# UNITED STATES PATENT AND TRADEMARK OFFICE

APPLICATION NO.	FILING DATE	FIRST NAMED INVENTOR	ATTORNEY DOCKET NO.	CONFIRMATION NO.
10/509,190	08/09/2005	Torsten Muller	B1180/20029	5188

<b>Office Action Summary</b>	<b>Application No.</b> 10/509,190	<b>Applicant(s)</b> MULLER ET AL.	
	<b>Examiner</b> Jay R. Ripley	<b>Art Unit</b> 3679

(Schick Figure 3A)

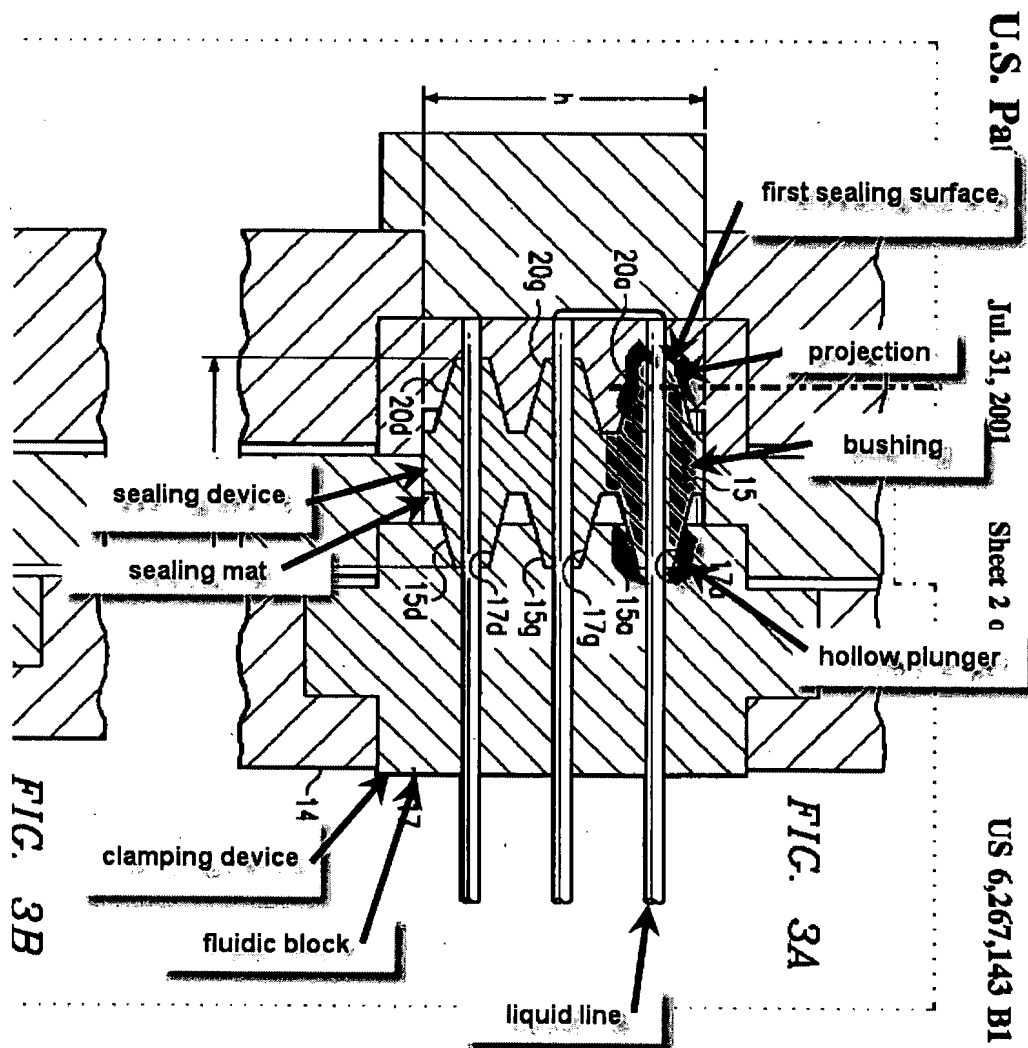
20. In regard to claim 1, Schick discloses in Figure 3A, below, a coupling device comprising:  
at least one sealing device having at least one bushing adapted to receive an end region of the at least one liquid line and having a first sealing surface adapted to contact an external surface of the fluidic system, an end of the at least one liquid line being laterally enclosed by the first sealing surface and pointing toward an opening in the external surface, and

a clamping device having at least one hollow plunger, forming a receptacle for at least a part of the at least one bushing, wherein the clamping device is adapted to press the bushing onto the fluidic system, so that the first sealing surface produces a liquid-tight connection with the external surface,

wherein the at least one hollow plunger is situated so as to be movable in relation to the external surface, the at least one bushing has an external shape, adapted to interact with an internal shape of the at least one hollow plunger of the clamping device in such a way that a force directed toward the external surface of the fluidic system is exerted on the at least one bushing using the at least one hollow plunger, and the at least one bushing has a projection forming the first sealing surface and an engagement surface for the clamping device.

23. In regard to claim 4, Schick further discloses, in Figure 3A above, that the bushing has an internal hollow channel (that which the liquid line is in), the internal hollow channel forming a second sealing surface (the channel has a surface) and the sealing device being able to be pressed against the end region of the at least one liquid line using the hollow plunger in such a way that the second sealing surface produces a liquid-tight connection with the surface of the end region.

25. In regard to claim 6, Schick further discloses in Figure 3A, above, that the first sealing surface is larger than a cross-sectional area of the end of the at least one liquid line (as is obviously observed as the liquid line is enclosed by the sealing surface).

26. In regard to claim 7, Schick further discloses in Figure 3A, above, multiple bushings provided on the at least one sealing device, the multiple bushings forming at least one sealing unit and being adapted to couple multiple liquid lines to the fluidic system simultaneously.

27. In regard to claim 8, Schick further discloses in Figure 3A, above, that the bushings of the sealing device are connected to one another in a row (three in a row in Figure 3A, above).

28. In regard to claim 9, Schick further discloses in Figure 3A, above, that the sealing unit forms a sealing mat, from which the bushings project.

29. In regard to claim 10, Schick further discloses in Figure 3A, above, that the clamping device comprises a fluidic block, in which hollow plungers are formed in accordance with an arrangement of the bushings of the at least one sealing unit.

(Schick Figure 1)

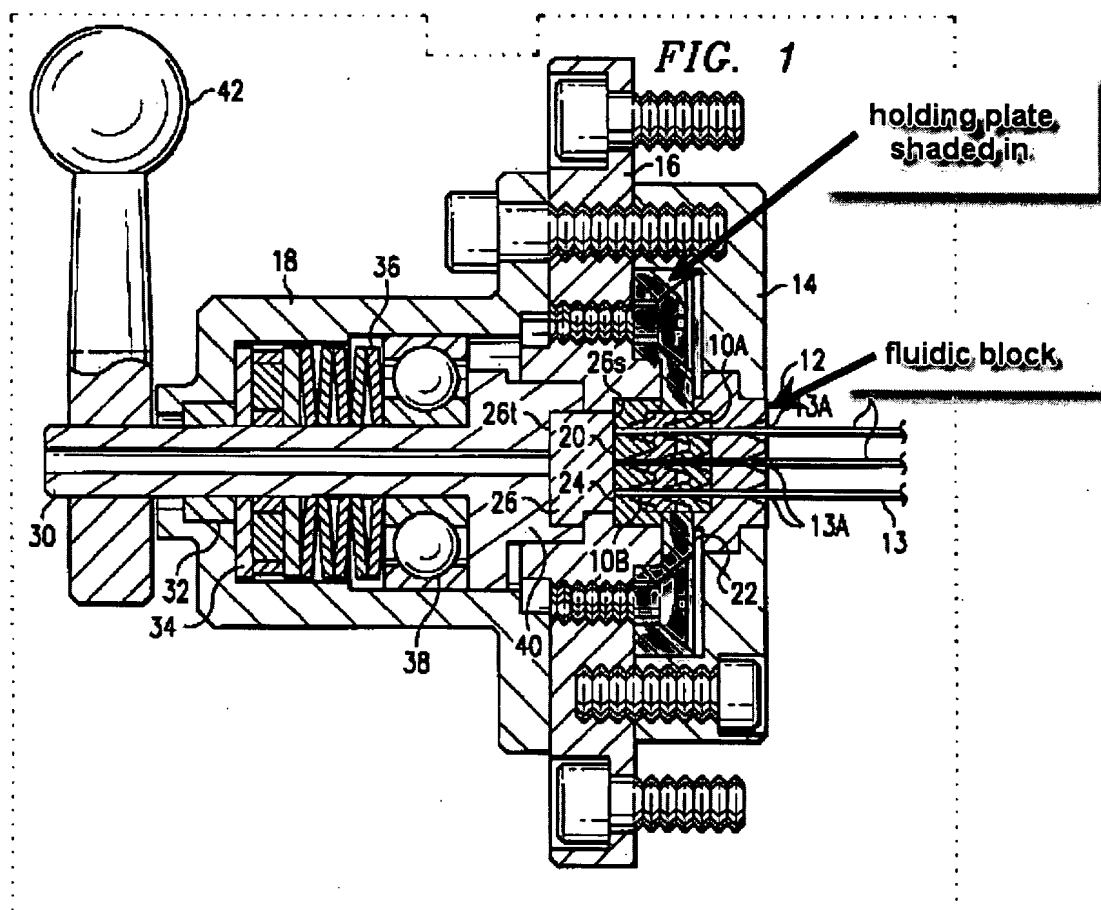
30. In regard to claim 11, Schick further discloses in Figure 1, below, a holding plate (22) permanently connected with the fluidic system and arranged for positioning the sealing unit on the fluidic system.

31. In regard to claim 12, Schick further discloses in Figure 1, above, that the fluidic block is arranged to be pressed onto the holding plate using a bayonet connector (the structure as disclosed by Schick has an appropriate arrangement to allow the fluidic block to be pressed onto the holding plate using a bayonet connector, therefore the claim limitations are met).

(Ghosh et al Figure 1)

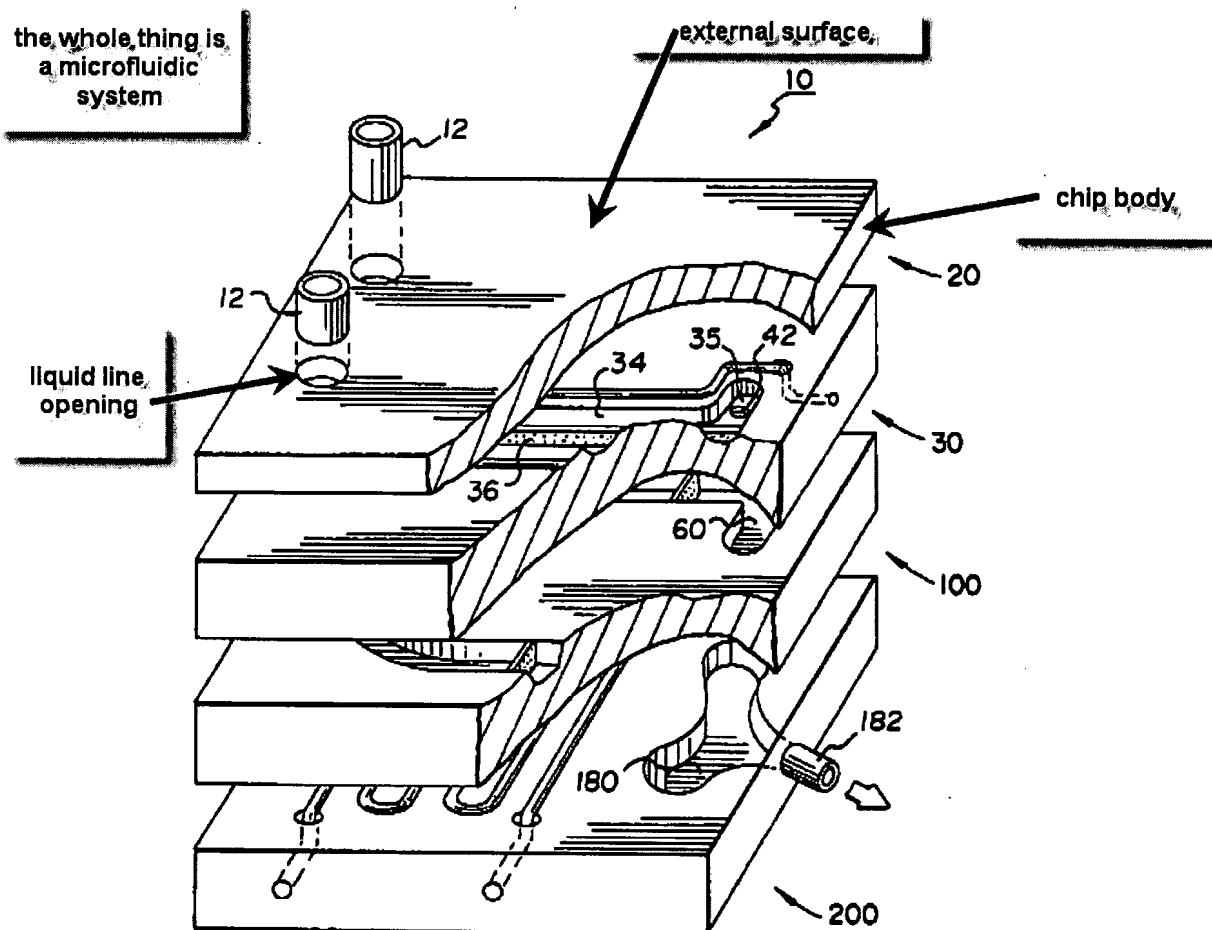
35. In regard to claim 13, Ghosh et al disclose in Figure 1, below, fluidic system (10) comprising a chip body (20).

36. In regard to claim 14, Ghosh et al further disclose in Figure 1, above, the chip body has an external surface, the external surface being planar at least in some sections and having at least one opening adjoined to a line end of the at least one liquid line.

37. In regard to claim 15, Ghosh et al further disclose in Figure 1, above, that the line end of the liquid line has a cylindrical external shape.

38. In regard to claim 16, Ghosh et al further disclose in Figure 1, above, that the fluidic system is a fluidic microsystem (The invention of Ghosh et al is a micro-chemical plant, therefore it is a fluidic microsystem).

(Fuller Figure 2)

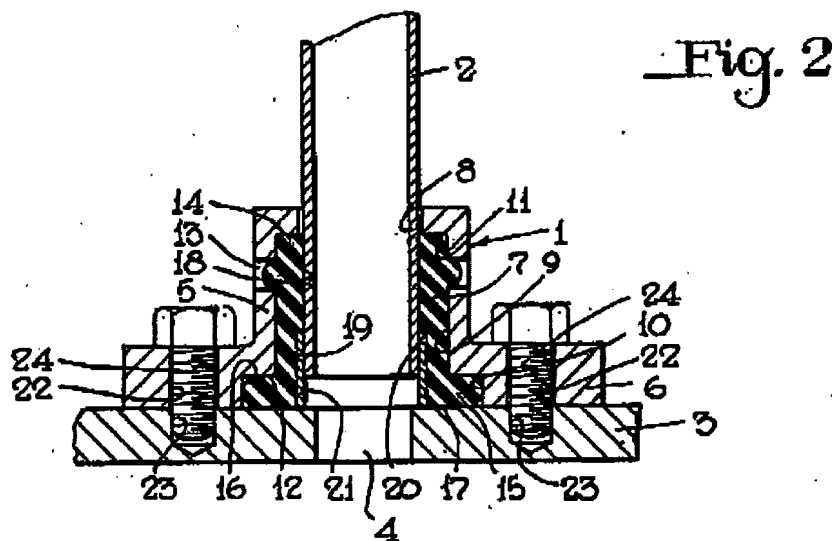
40. In regard to claim 17, Fuller disclose, in Figure 2 below, a method for liquid-tight coupling of a liquid line to a fluidic system, the method comprising:

forming a composite of at least one liquid line (2) with a bushing (7), a clamping device (1), and a fluidic system (3 is the wall of the system), and

actuating the clamping device to produce a contact pressure on a projection of the bushing (column 3, lines 12-30) in such a way that the sealing device forms the liquid-tight connection with the external surface of the fluidic system.
